Location Address: 2328 JACKSON ST, HOLLYWOOD FL 33020
Lot(s): 13 Block(s): 4 Subdivision: HOLLYWOOD LITTLE RANCHES

Explanation of Request: NEW CONSTRUCTION 33 UNIT RENTAL APARTMENT BUILDING

SUBJECT: Preliminary Site Plan and Design review for 33 Residential Units.

A-03

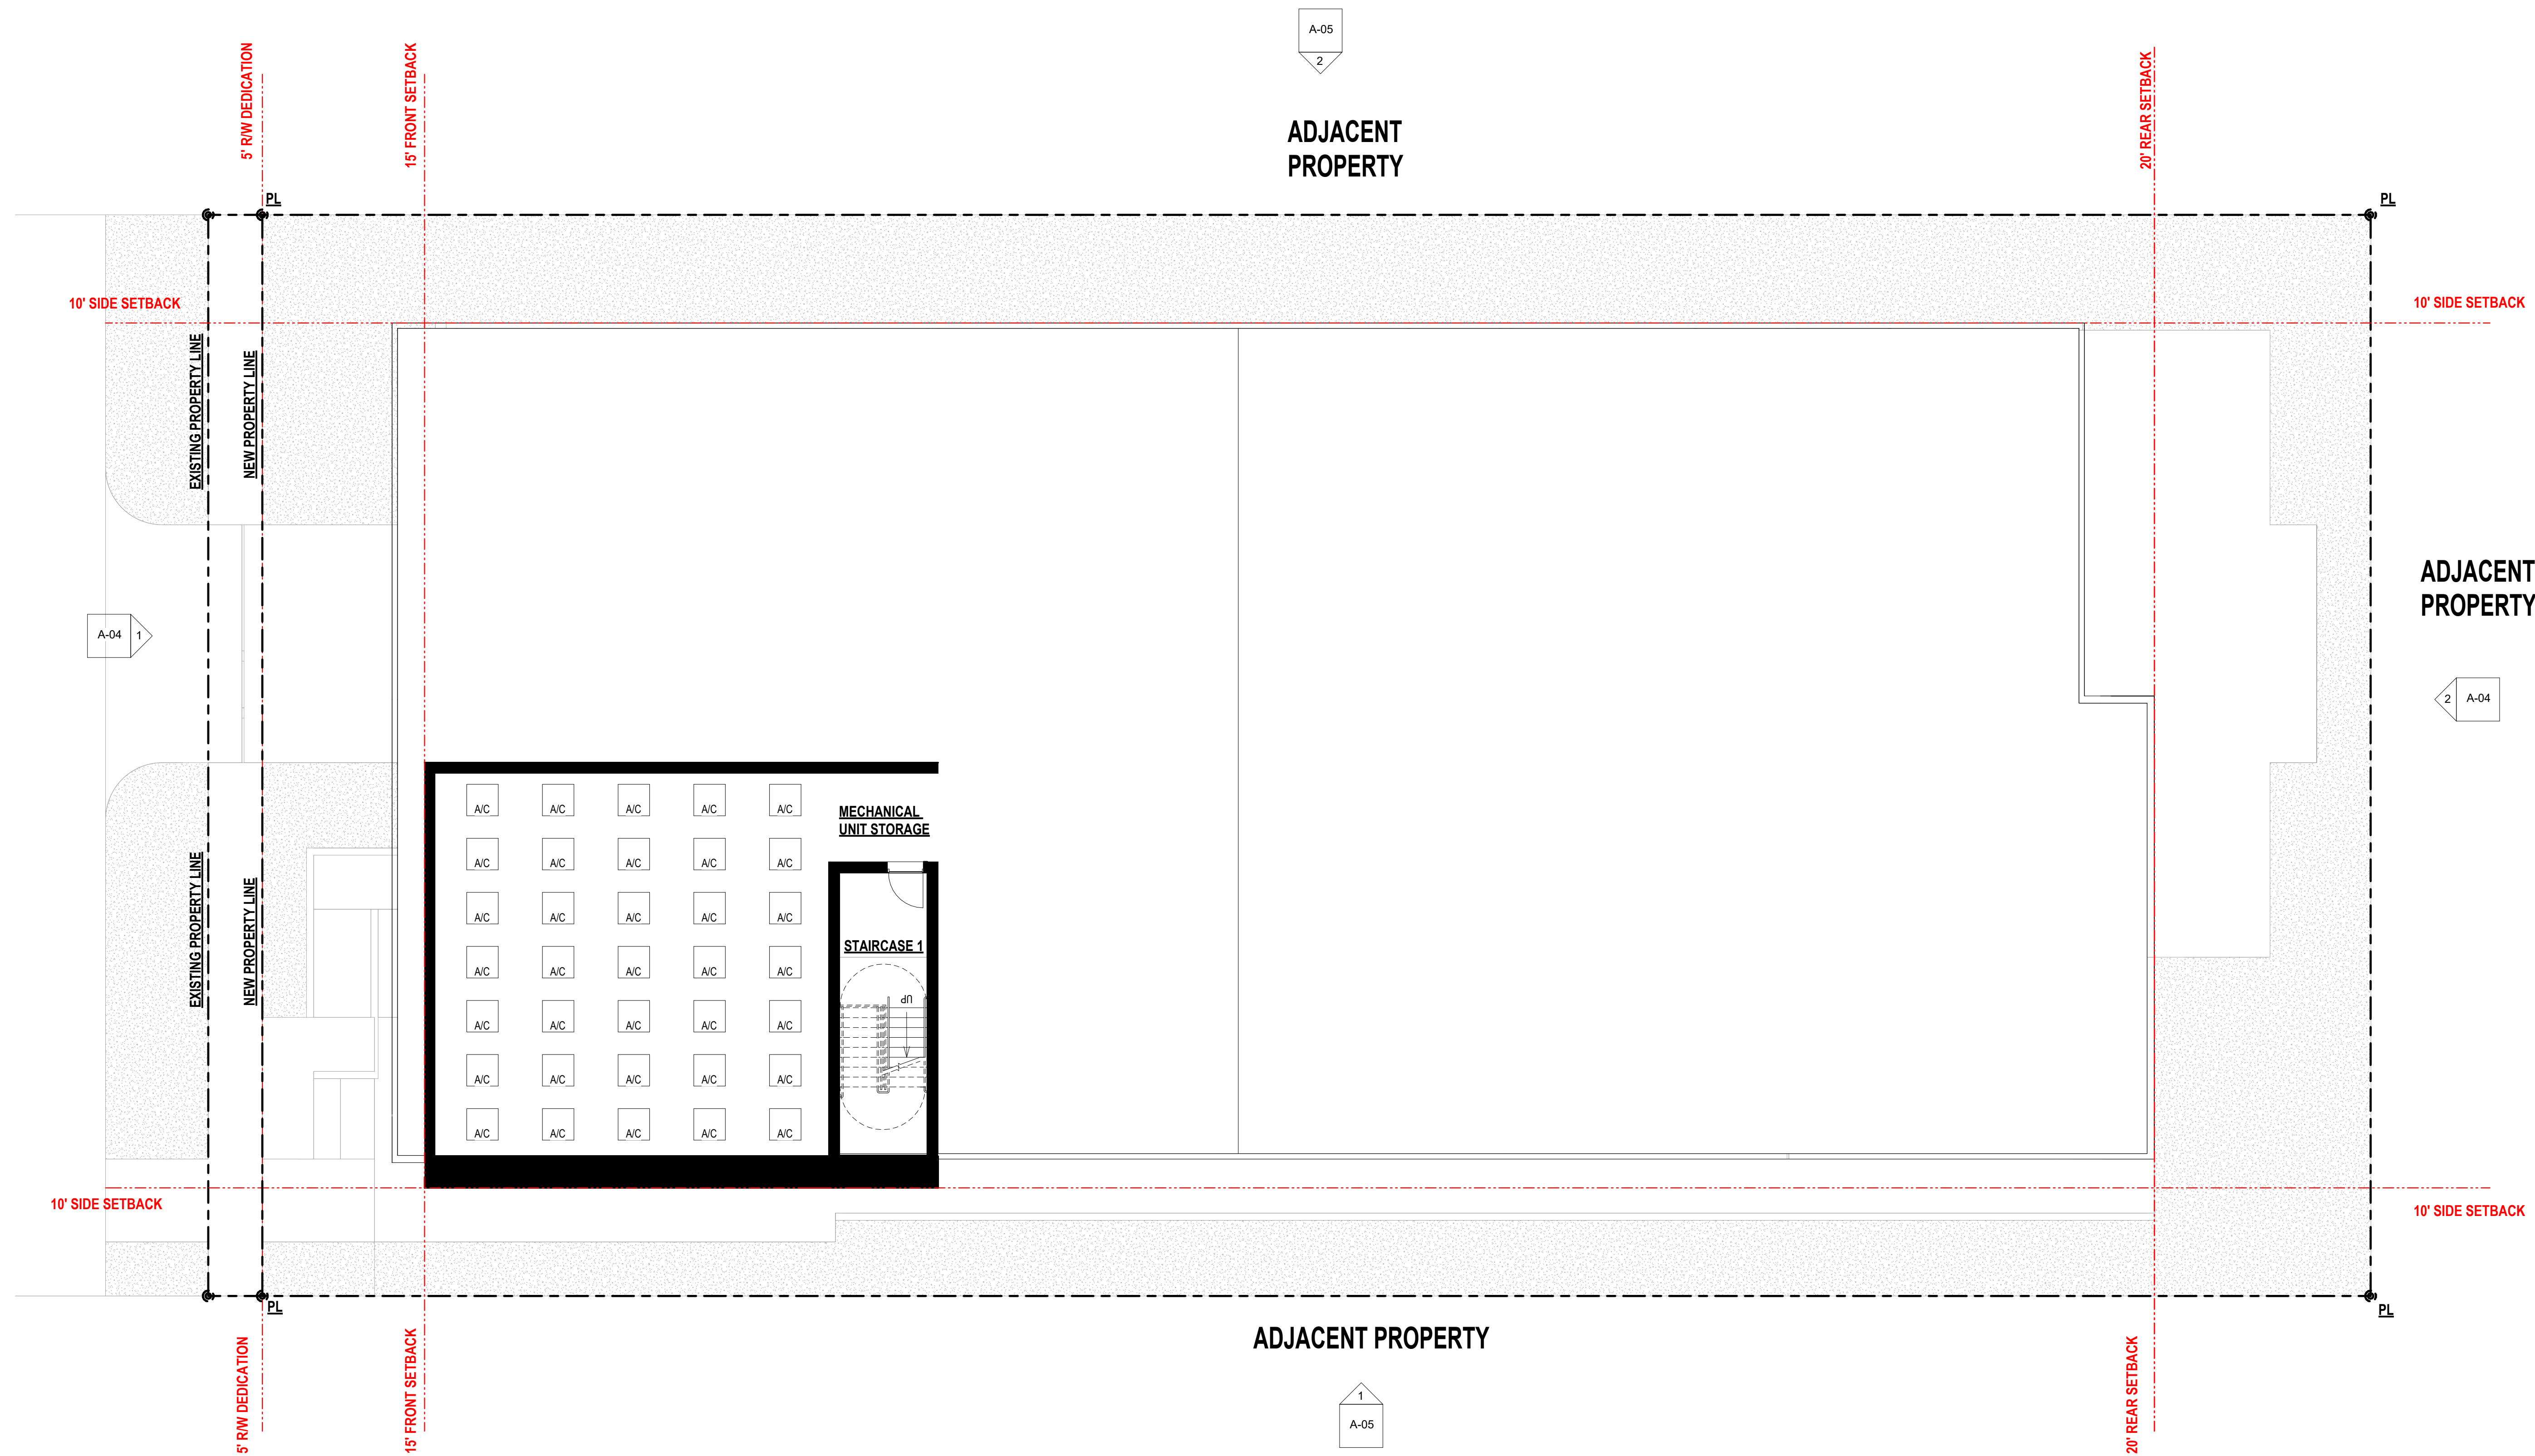
- d. No roof plan provided. Will this be the location of mechanical equipment? Are there any rooftop amenities?

R:/ Roof plan added to set. Mechanical units will be stored at roof deck level with access from the lobby entrance staircase.

A-04

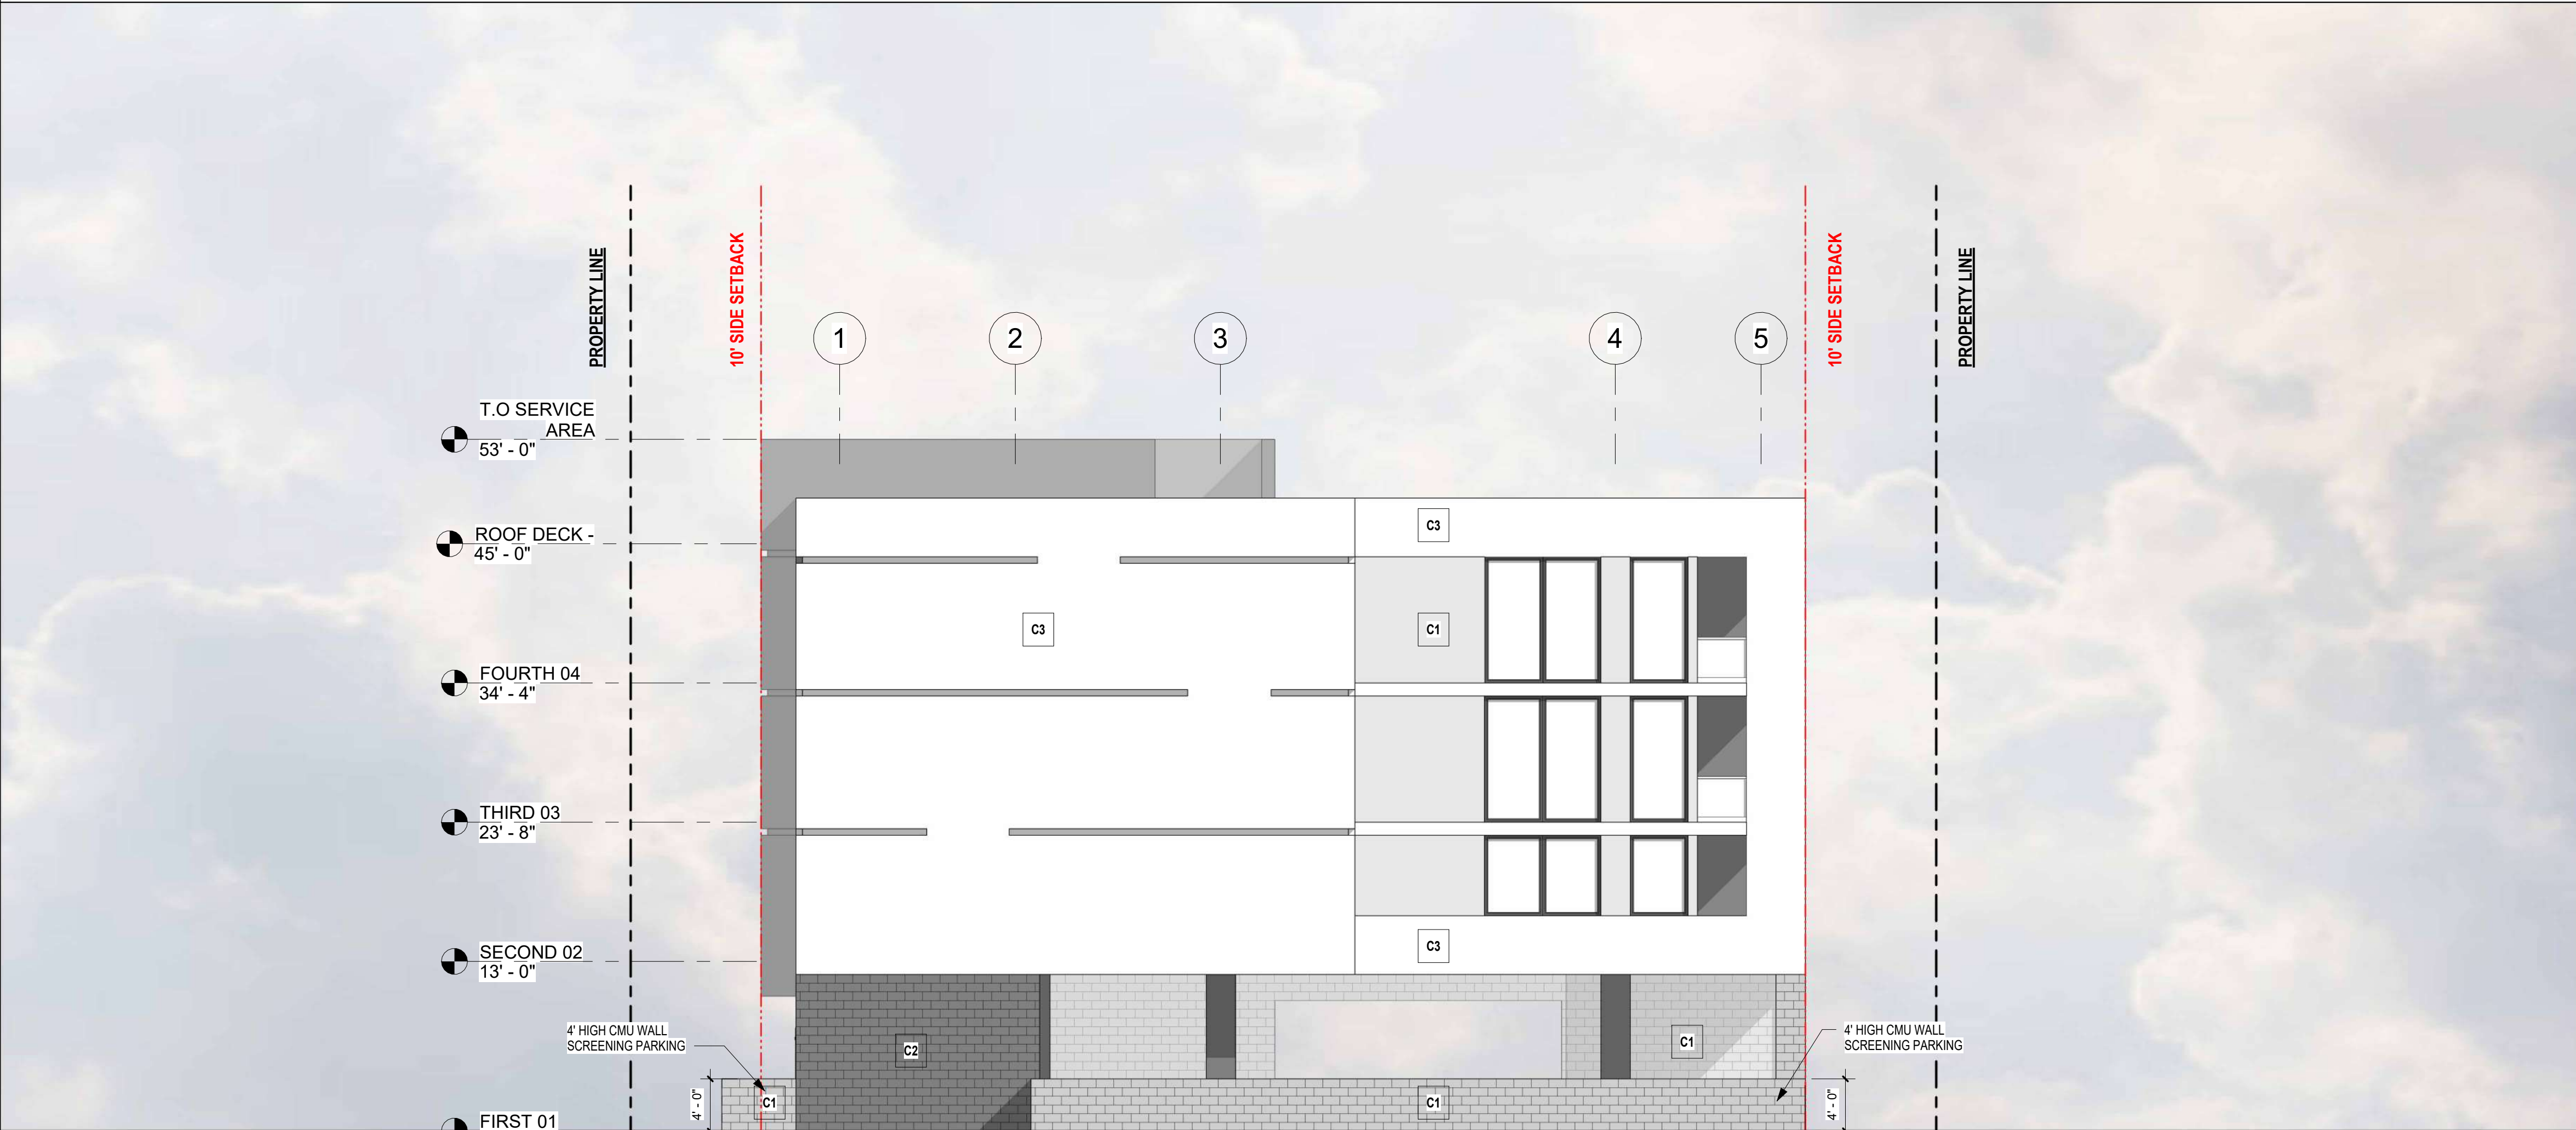
1. Provide material legend elevations.

Sheet A-04 **R:/ Material shown on elevations with keynote legend.**

EROSION & SEDIMENT CONTROL PLAN

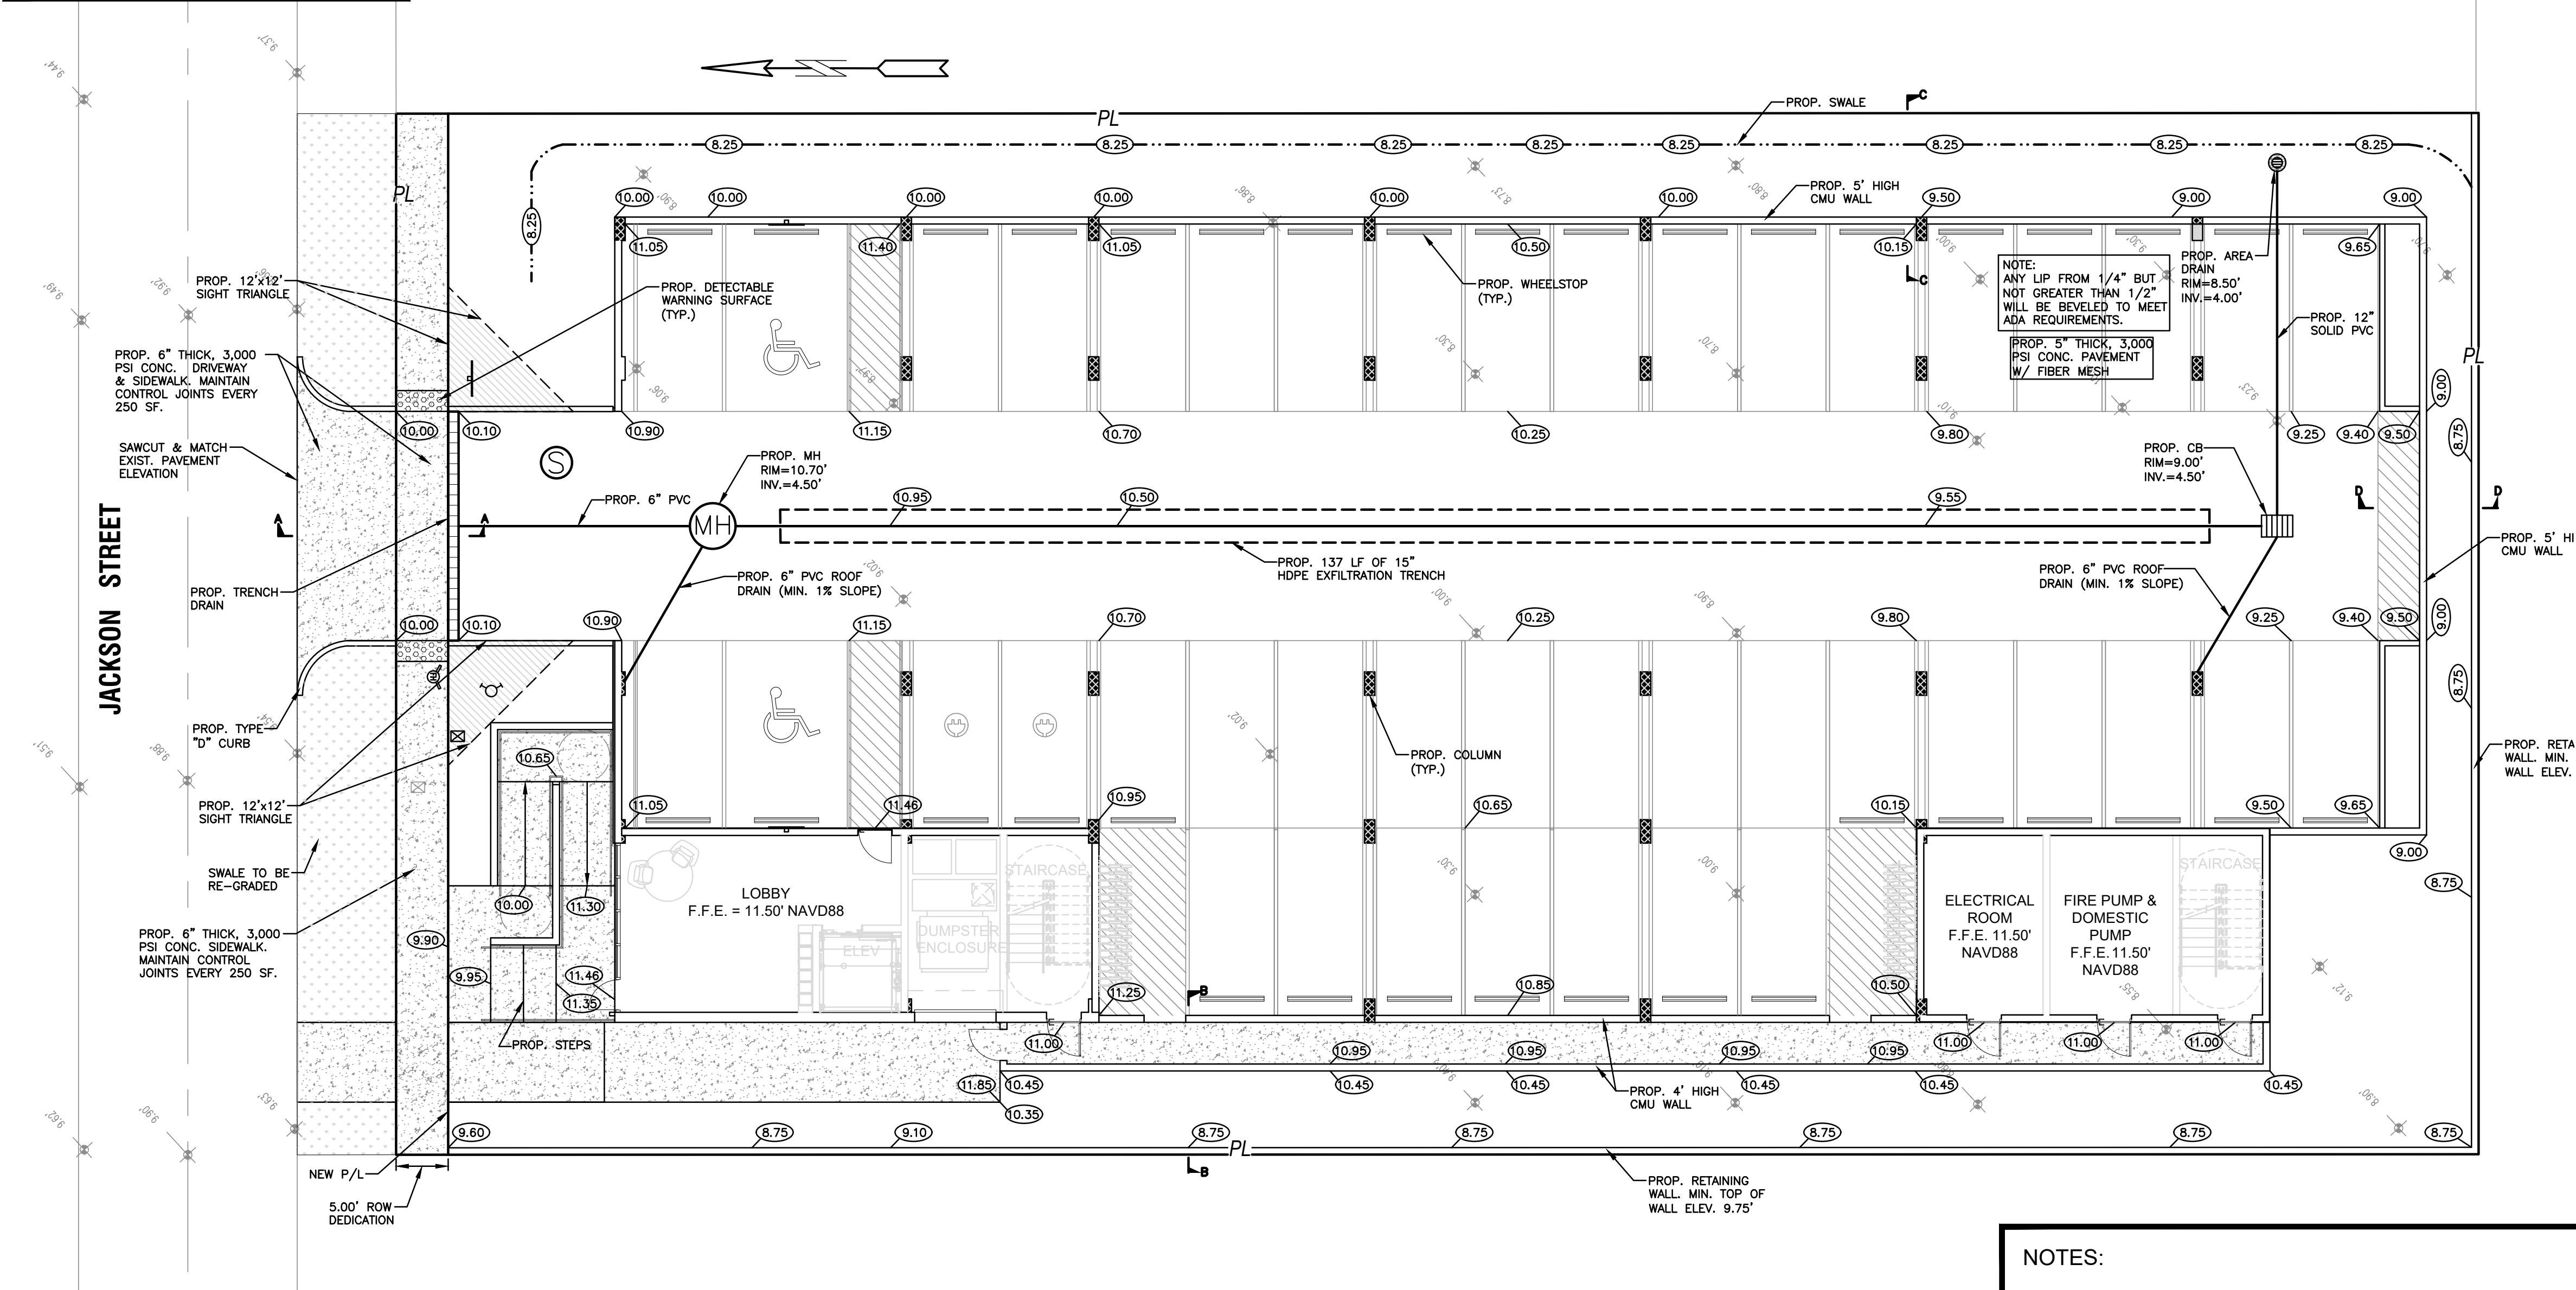
11. Submit Erosion Control Plan.

RESPONSE: Please see sheet C1.
